VALUE ENGINEERING STUDY

Project # IM000-0285-01(346) PI No. 713210-

I-75 NB C-D System from Forest Parkway to I-285
Clayton County, Georgia

25 August 2011

PROPOSAL NUMBER: R-1.0

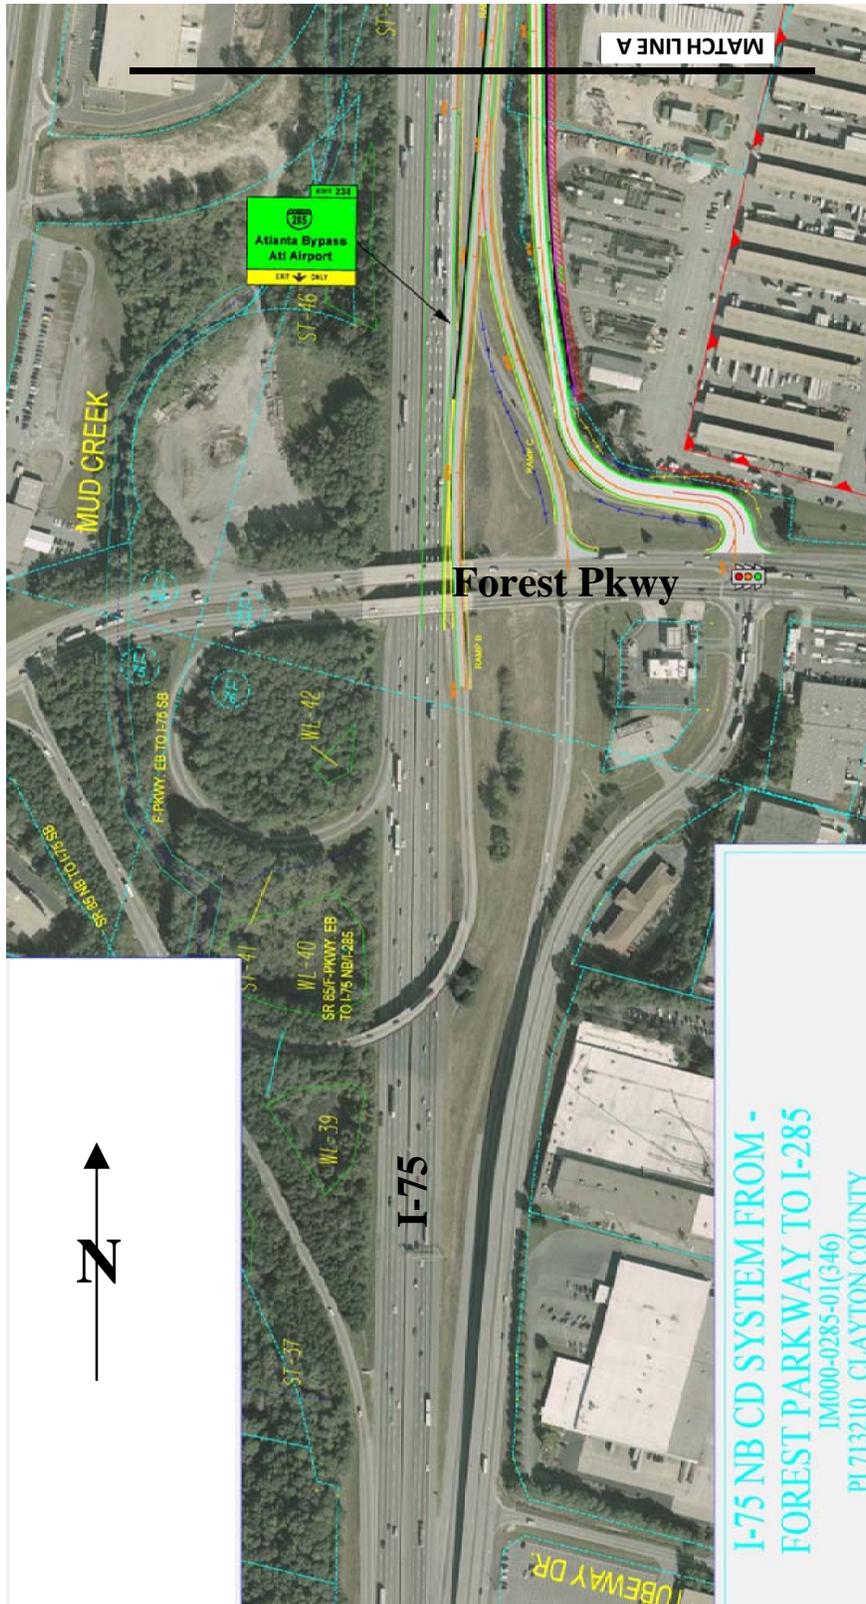
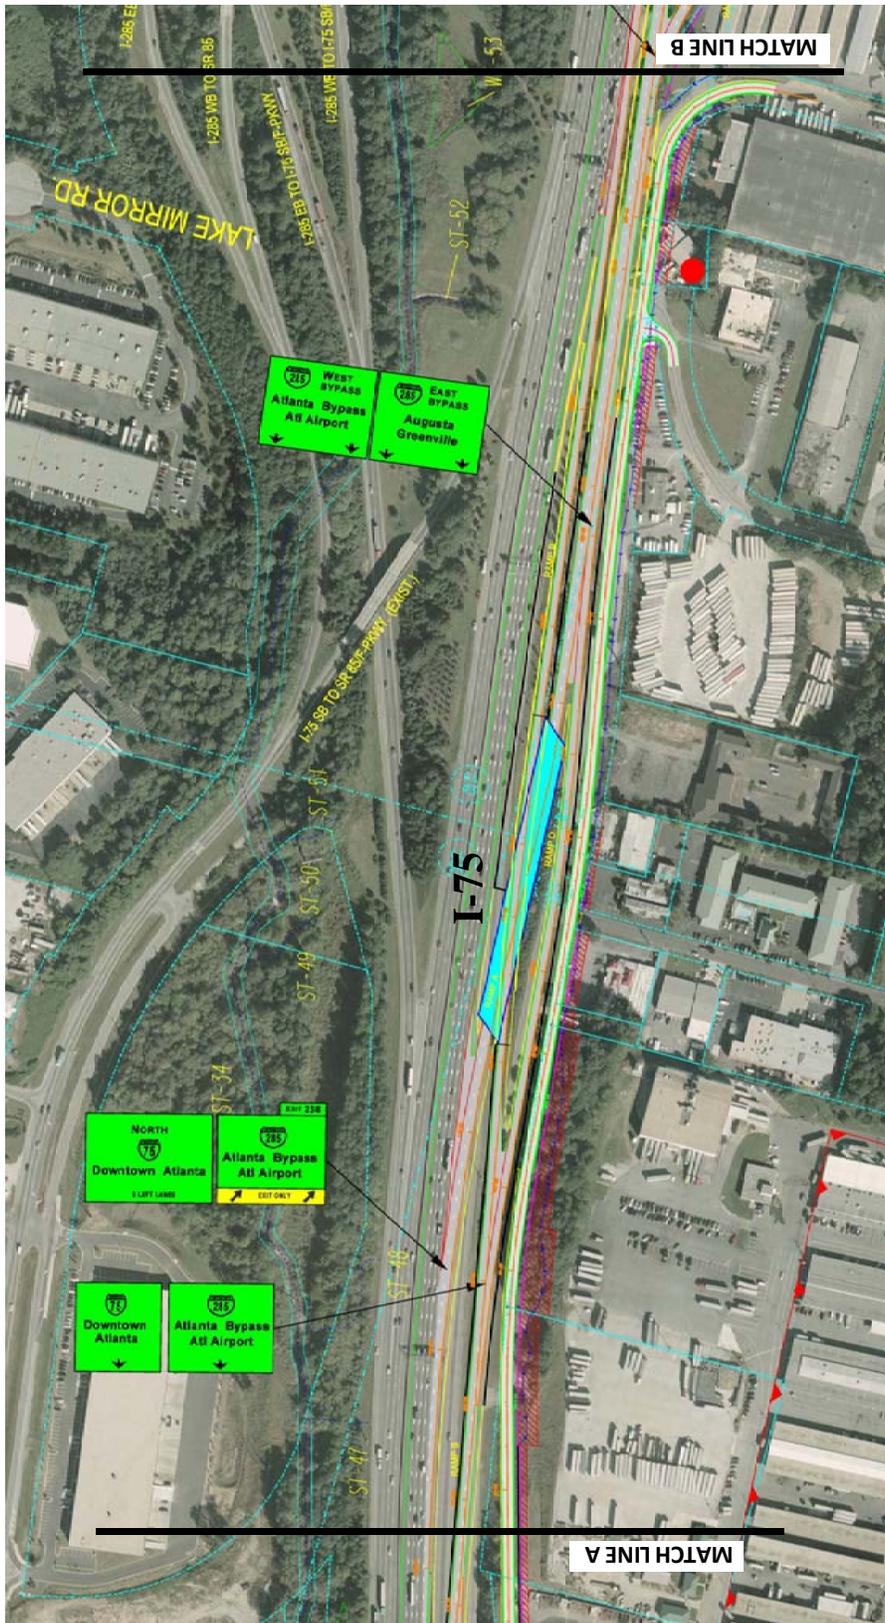
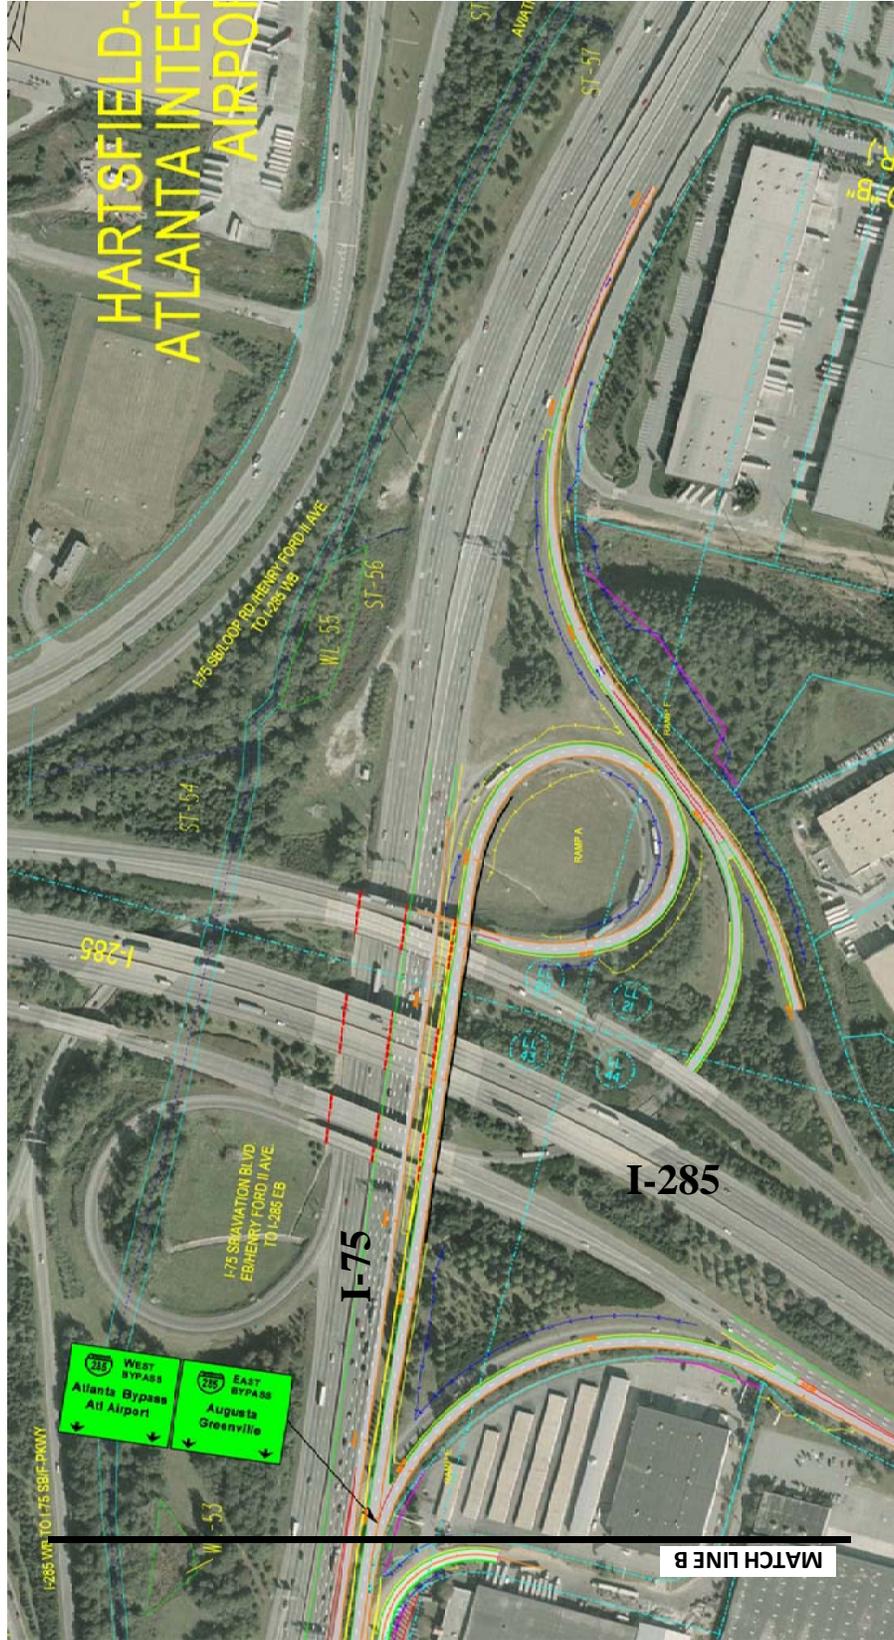
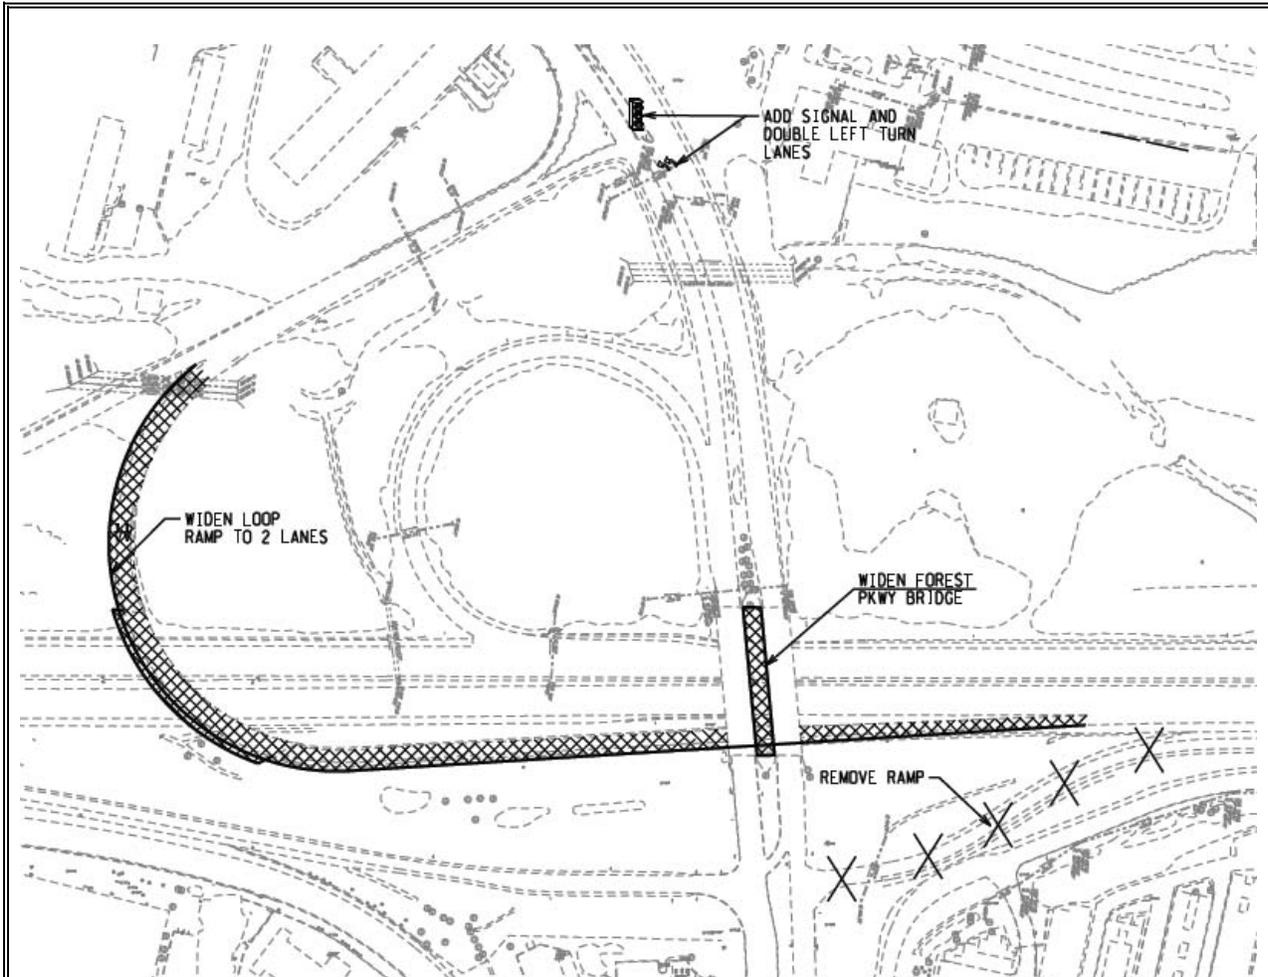
PROPOSED CHANGE: It is proposed to eliminate one of the entrance ramps from Forest Parkway (Ramp 'C') and widen the existing flyover loop ramp to 2 lanes. Do not construct the remaining portion of the project. Widen Forest Parkway bridges over I-75 to develop additional storage on Forest Pkwy for 2-lane left turn from westbound onto entrance ramp for I-75N.

Note: Proposed Change only widens the flyover ramp to 2 lanes, adds signal and double-left turn to flyover ramp, widens the Forest Parkway Bridges over I-75, removes ramp "C", and does not construct remainder of project corridor.

PROPOSAL NUMBER: R-1.1

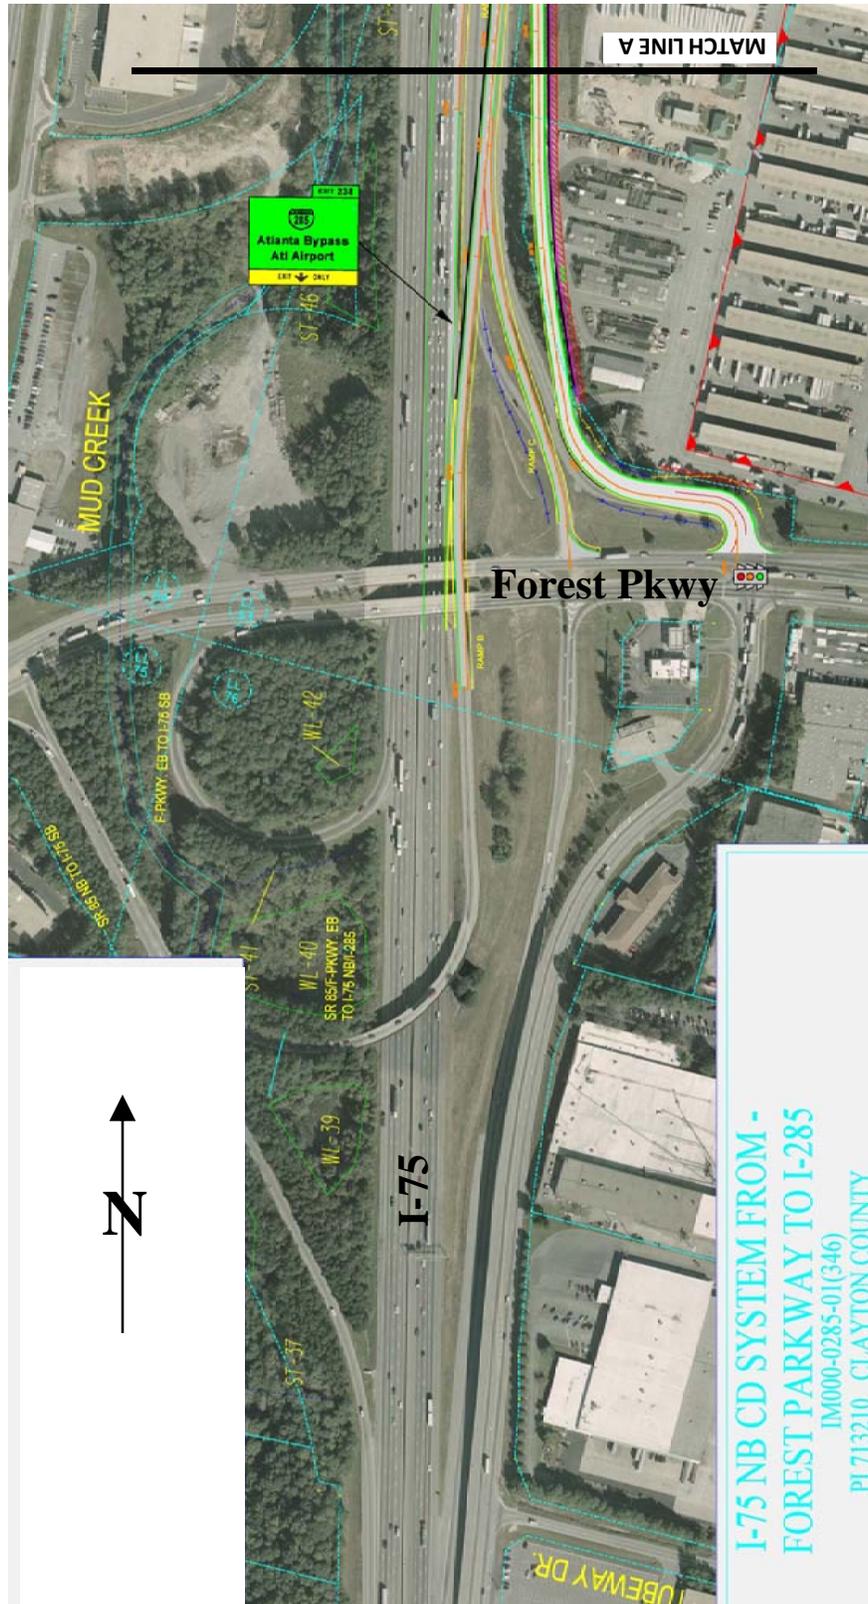
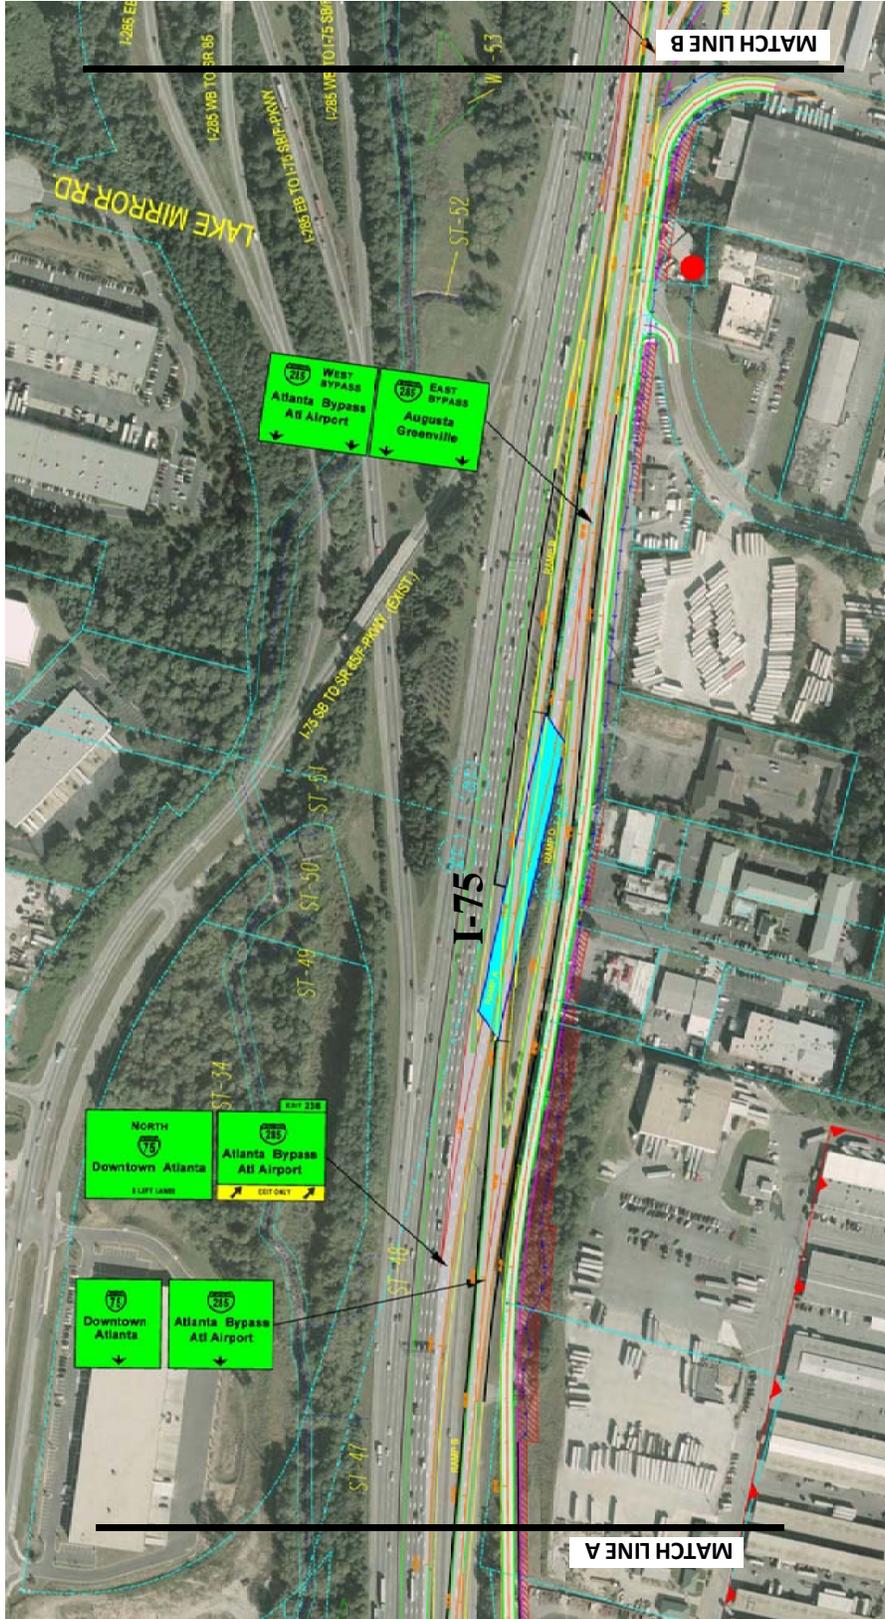
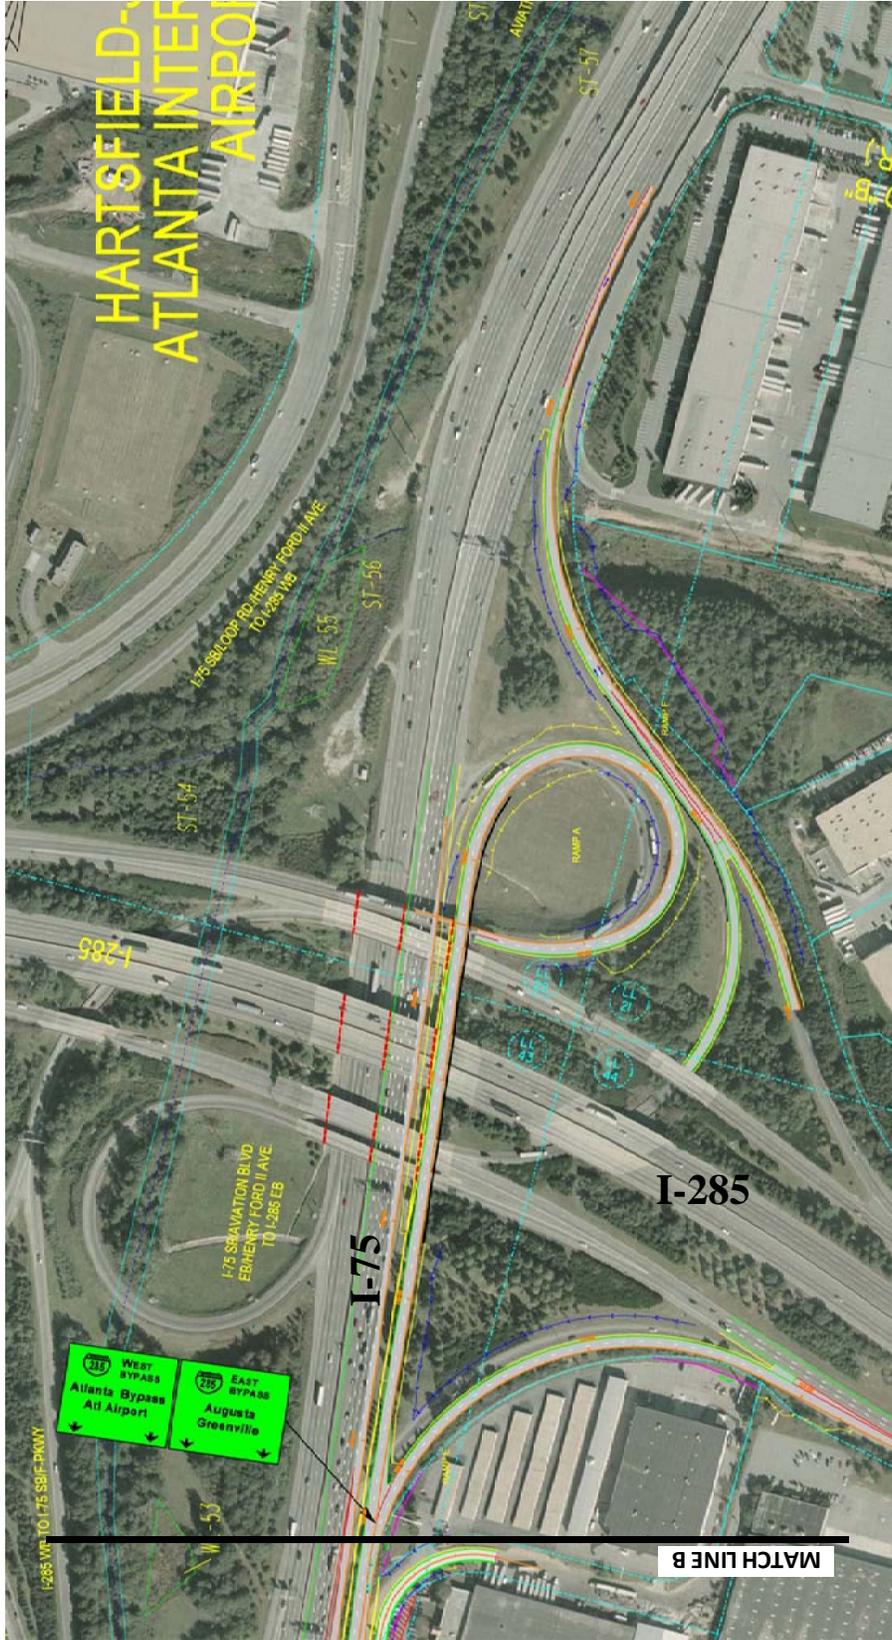
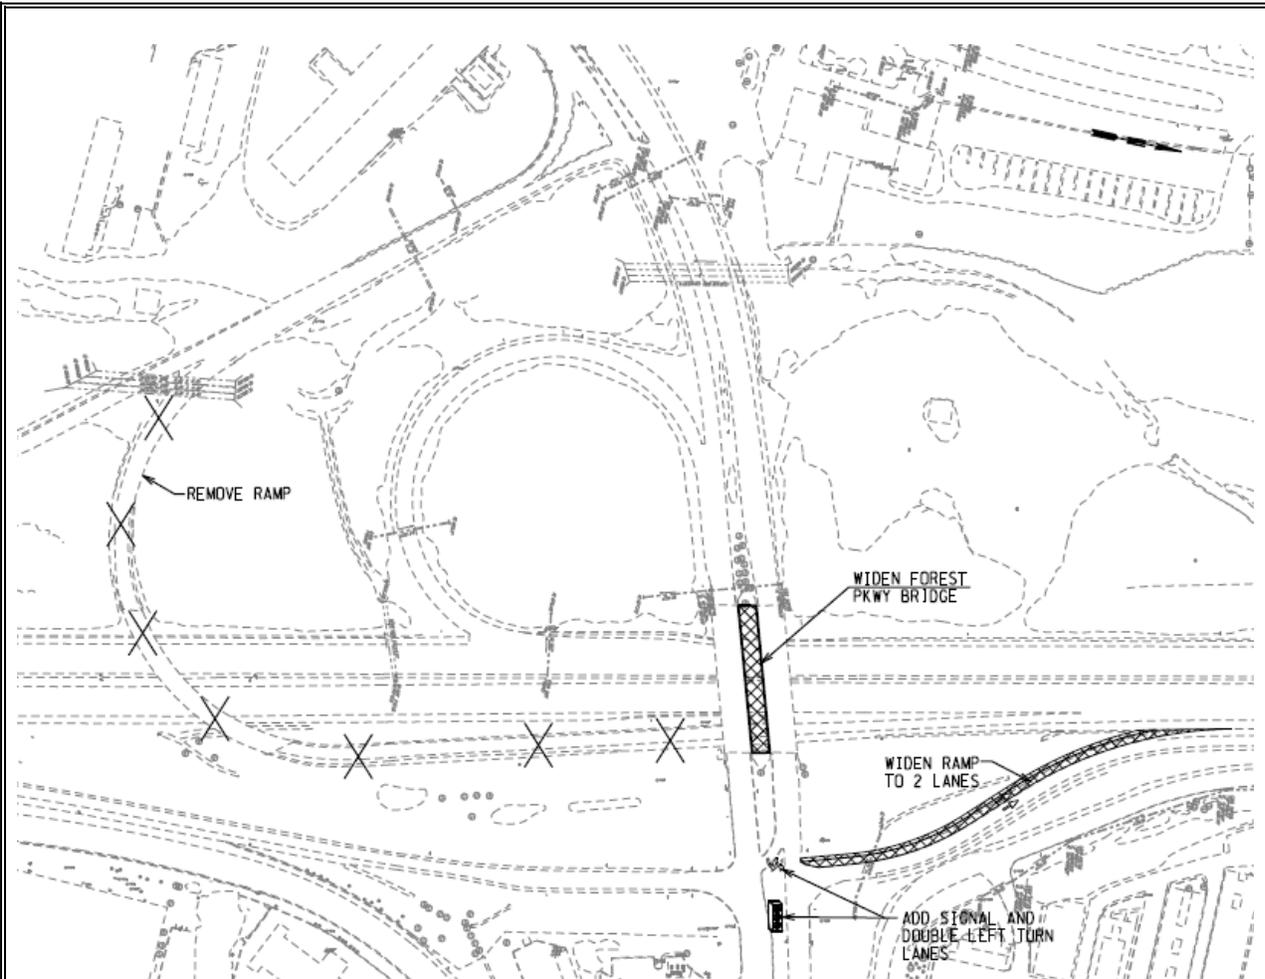
PROPOSED CHANGE: It is proposed to eliminate the existing looped entrance ramp from Forest Parkway to I-75 North and widen the remaining ramp to 2 lanes. Do not construct the remaining portion of the project. Widen Forest Parkway bridges over I-75 to develop additional storage on Forest Parkway for 2-lane left turn onto entrance ramp. Add a traffic signal at intersection with ramp.

Note: Proposed change removes the flyover ramp, widens the Forest Parkway Bridges over I-75, adds a signal and double left-turn lanes from Forest Parkway eastbound to I-75N ramp, and widens ramp "C" to I-75N to 2 lanes. Remainder of project corridor is not constructed.
